# WAITSFIELD DEVELOPMENT REVIEW BOARD MEETING AGENDA

STAFF REPORT by J.B. Weir for February 27, 2024 Meeting

Application #: 4165-CU

Proposal/Type: Requesting approval to construct two self-storage

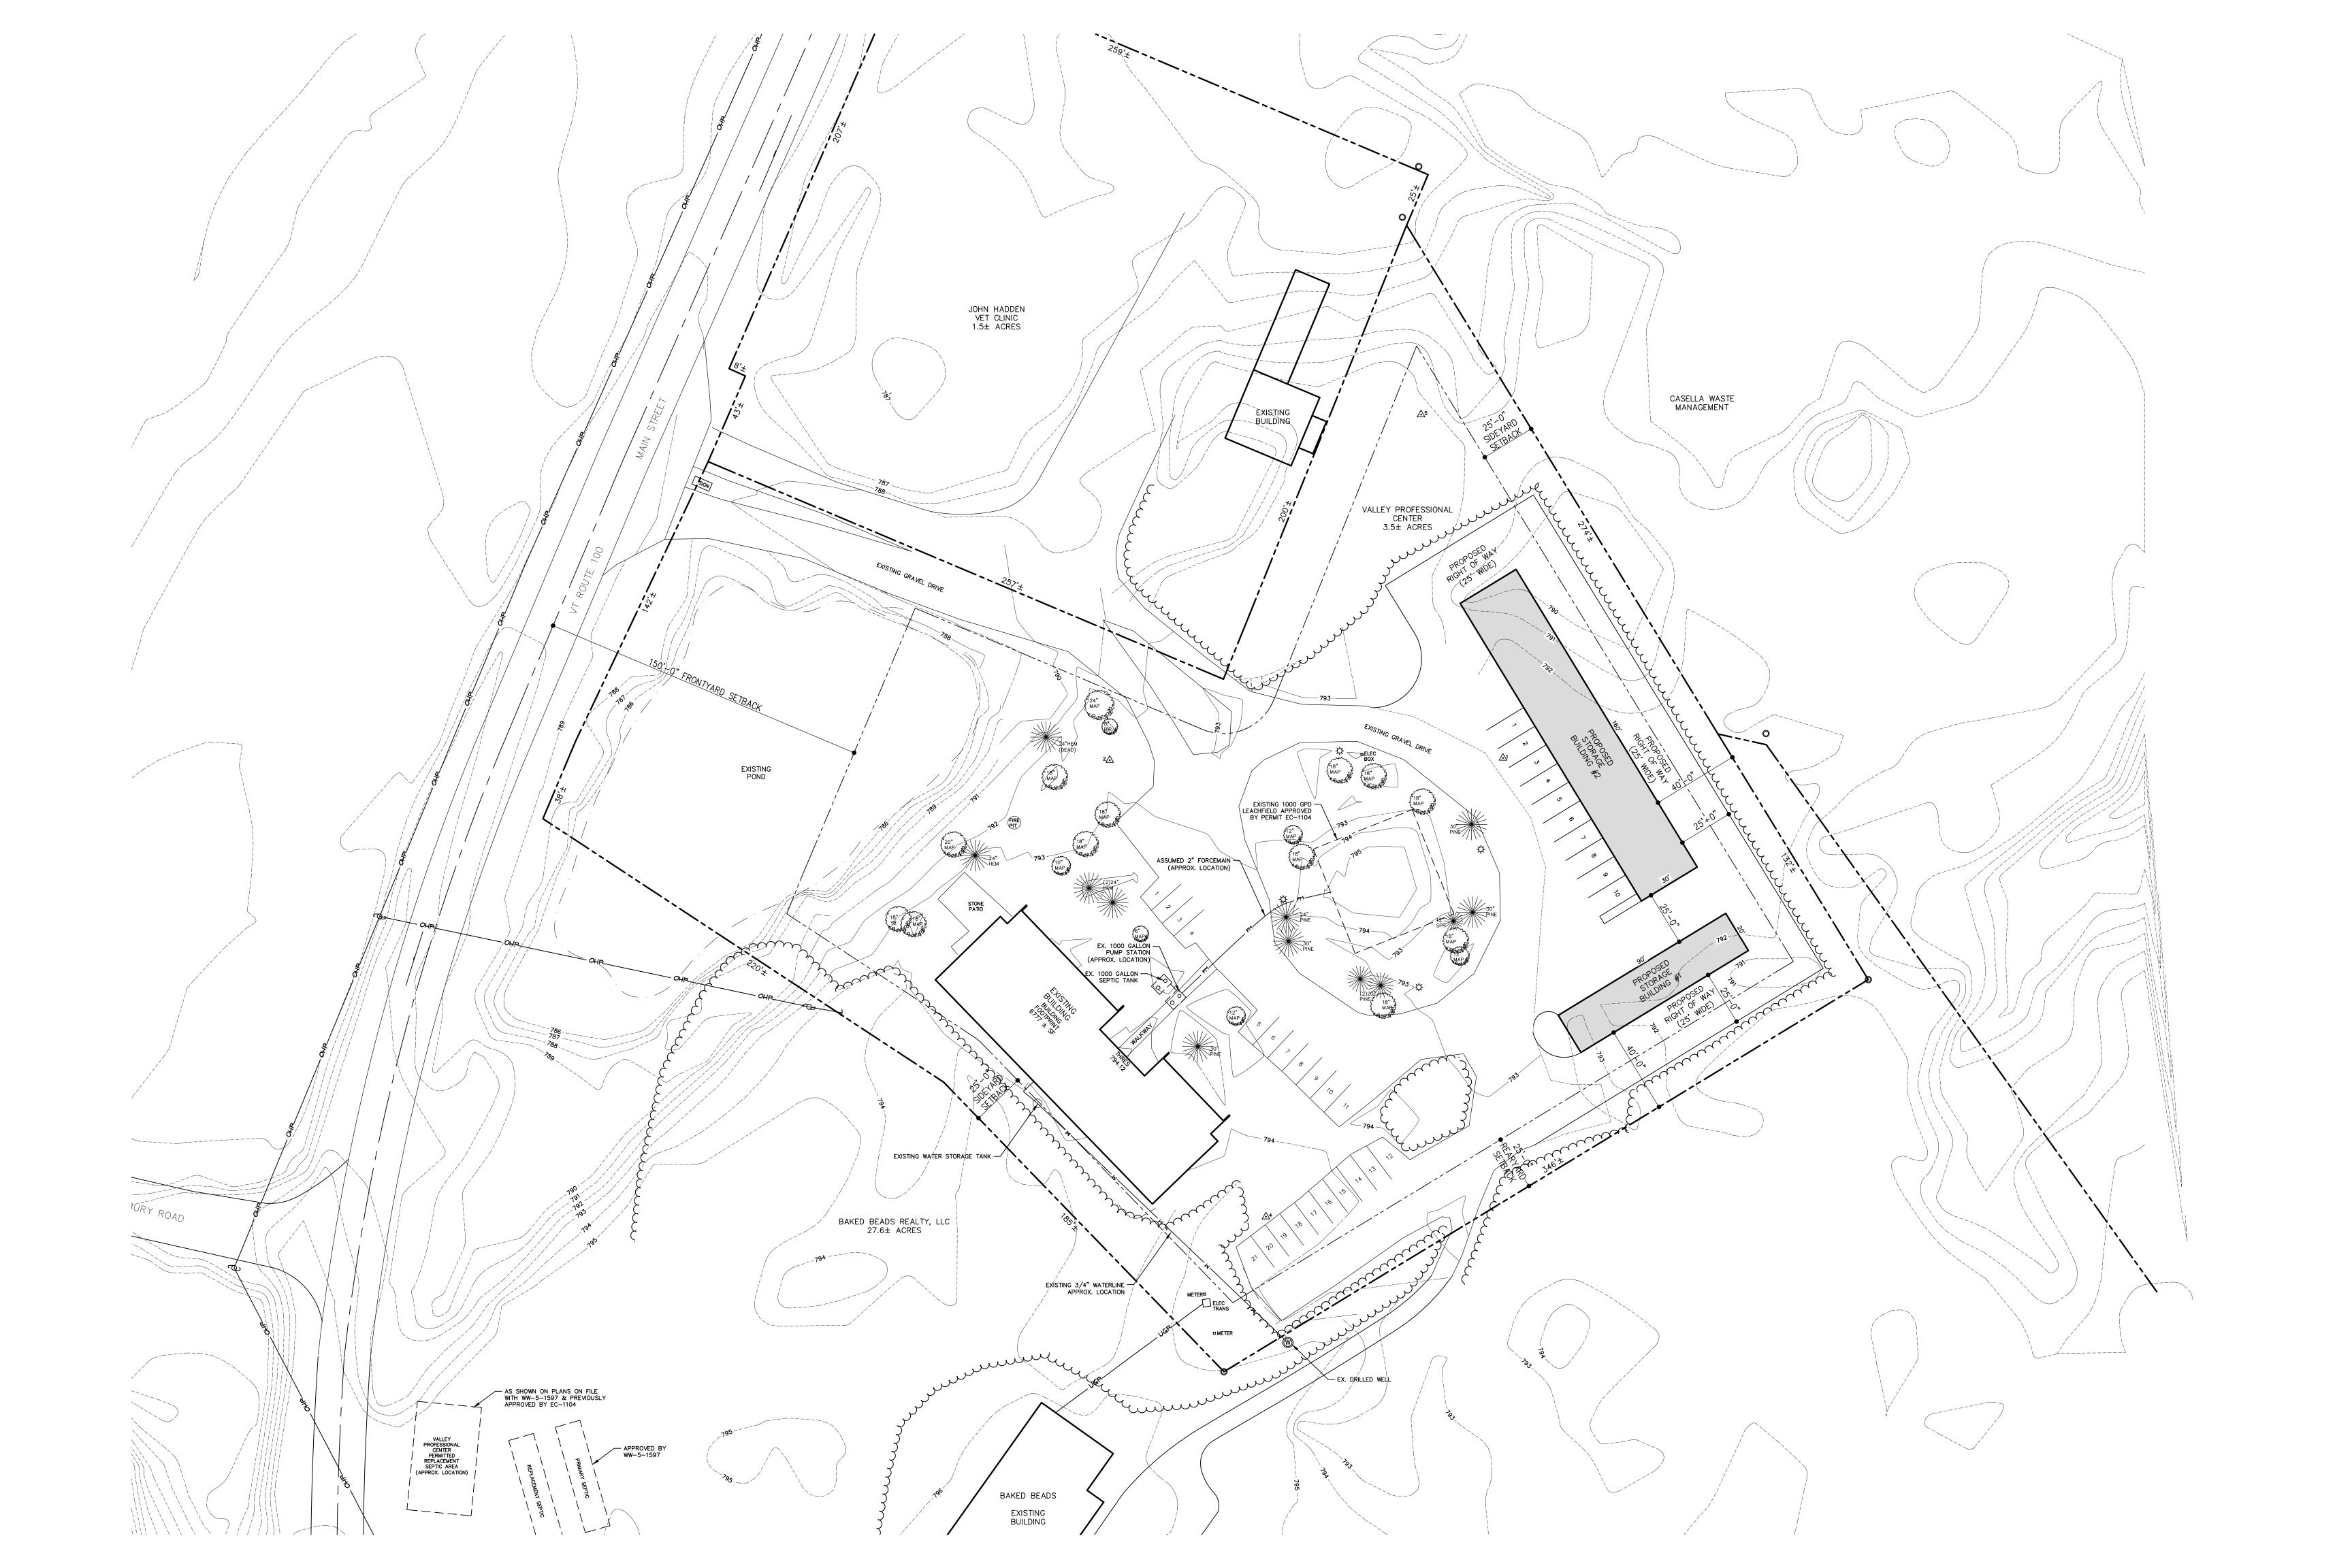
- 9. Parking for the mixed-use building is existing. There are 21 parking spaces for the existing building as shown on the site plan. Per Table 3.1, multi-family dwellings require one space per unit. There are three apartments. Therefore, three spaces are required for

the dwelling units. Table 3.1 requires one parking space per 300 sq. ft. gross floor area for professional office space. Once construction is done on the third apartment, there will be approximately 7,300 sq. ft. of commercial office space. 24 parking spaces are therefore required for 7,300 sq. ft. of office space. Accordingly, a total of 27 parking spaces would be required for the existing mixed-use building. Applicant's site plan depicts 21 total existing spaces.

- 10. Applicant proposes an additional 10 parking spaces for the two storage units. Per Table 3.1, storage warehouses require one space per 1,000 sq. ft. of gross floor area. Applicant proposes 6,600 sq. ft. of storage, thereby requiring 7 spaces.

- 11. In all, 34 parking spaces are required for the mixed uses as proposed on the parcel (27 for the multi-family dwelling and office space and 7 for the storage units). Applicant's site plan reflects 31 total spaces. The PZA notes that the professional center's uses are existing, but recommends that the Board ensure there is overflow parking for the professional center/apartments in order that Section 4.08 (C) be deemed satisfied. Alternatively, the Board could recommend that the applicant provide for 3 additional spaces on the site plan.
